FIELD REPORT – CARILLON POINT BUILDING 4000 – FIELD REPORT

Report Number: 11

Project No. 10-030608K1

4000 Carillon Point
Kirkland, Washington

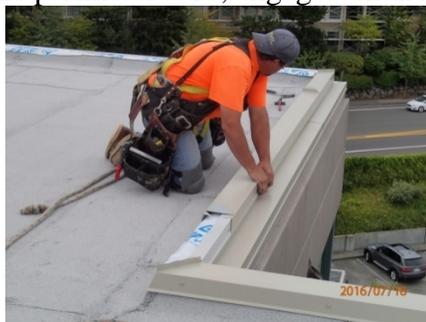
11.1 The continuous sheet metal L-clip is installed on the step down of the outer curb and along the top of the curb. A hammer drill is utilized to drill the clip and concrete and concrete fasteners are installed, securing the clip, spaced approximately 24-inches on center. A separate L-metal clip is installed at the top outside corner of the parapet to secure the coping metal.

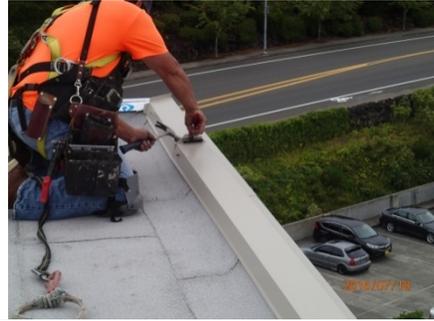
11.5 The standing seams are folded over with a hammer and tongs.

11.6 DOW Corning 795 sealant is applied at the corners of the installed coping and at the standing seams. The sealant is tooled by hand as necessary.

11.7 Photos depict installed condition of the standing seam sheet metal coping along the perimeter of the roof. The coping is secured with gasketed fasteners spaced approximately 24-inches on center along the interior face.
